EASA	AIRWORTHINESS DIRECTIVE
	<p>AD No.: 2011-0006</p> <p>Date: 17 January 2011</p> <p>Note: This Airworthiness Directive (AD) is issued by EASA, acting in accordance with Regulation (EC) No 216/2008 on behalf of the European Community, its Member States and of the European third countries that participate in the activities of EASA under Article 66 of that Regulation.</p>
This AD is issued in accordance with EC 1702/2003, Part 21A.3B. In accordance with EC 2042/2003 Annex I, Part M.A.301, the continuing airworthiness of an aircraft shall be ensured by accomplishing any applicable ADs. Consequently, no person may operate an aircraft to which an AD applies, except in accordance with the requirements of that AD unless otherwise specified by the Agency [EC 2042/2003 Annex I, Part M.A.303] or agreed with the Authority of the State of Registry [EC 216/2008, Article 14(4) exemption].	
Type Approval Holder's Name :	Type/Model designation(s) :

AIRBUS	A300, A310, A300-600 and A300-600ST aeroplanes
TCDS Number :	France No.145 and EASA.A.014
Foreign AD :	Not applicable
Supersedure :	None
ATA 29	Hydraulic Power – Hydraulic Accumulator – Inspection / Replacement / Placards Installation
Manufact

Appendix 1

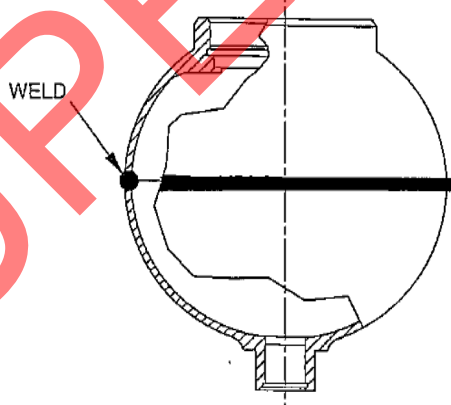
HYDRAULIC ACCUMULATOR : designed with 4 parts and 3 welds

OLD DESIGN

HYDRAULIC ACCUMULATOR : designed with 2 parts and 1 weld

NEW DESIGN

<p>(2) If, during the visual inspection as required by paragraph (1) of this AD, an old design hydraulic accumulator is found installed on any of the affected hydraulic circuits as indicated in Table 1 of this AD, as applicable to aeroplane model, replace each affected old design accumulator with a new design accumulator in accordance with the instructions of Airbus SB A300-29-0126 Revision 01, SB A310-29-2099, SB A300-29-6063, or SB A300-29-9012, as applicable to aeroplane model.</p> <p>(3) Irrespective of findings during the visual inspection as required by paragraph (1) of this AD, install placards at the designated locations of the affected hydraulic circuits indicated in Table 1 of this AD, as applicable to aeroplane model, in accordance with the instructions of Airbus SB A300-29-0127, SB A310-29-2100, SB A300-29-6064, or SB A300-29-9013, as applicable to aeroplane model.</p>	Affected Aeroplanes	Affected Hydraulic Circuit(s)	A300 PRE mod 02447	Blue and Green	A300 POST mod 2447	Blue	A300-600 and A300F4-608ST	Blue	A310	Green
Affected Aeroplanes	Affected Hydraulic Circuit(s)										
A300 PRE mod 02447	Blue and Green										
A300 POST mod 2447	Blue										
A300-600 and A300F4-608ST	Blue										
A310	Green										
Ref. Publications:	<p>Airbus SB A300-29-0126 Revision 01 and SB A300-29-0127 original issue.</p> <p>Airbus SB A310-29-2099 and SB A310-29-2100, both original issue.</p> <p>Airbus SB A300-29-6063 and SB A300-29-6064, both original issue.</p> <p>Airbus SB A300-29-9012 and SB A300-29-9013, both original issue.</p> <p>The use of later approved revisions of these documents is acceptable for compliance with the requirements of this AD.</p>										
Remarks :	<ol style="list-style-type: none"> If requested and appropriately substantiated, EASA can approve Alternative Methods of Compliance for this AD. This AD was posted on 15 December 2010 as PAD 10-122 for consultation until 12 January 2011. The Comment Response Document can be found at http://ad.easa.europa.eu/. Enquiries regarding this AD should be referred to the Airworthiness Directives, Safety Management & Research Section, Certification Directorate, EASA E-mail: ADs@easa.europa.eu. For any question concerning the technical content of the requirements in this AD, please contact: AIRBUS SAS – EAW (Airworthiness Office, Telephone: + 33 5 61 93 36 96, Fax: + 33 5 61 93 44 51).
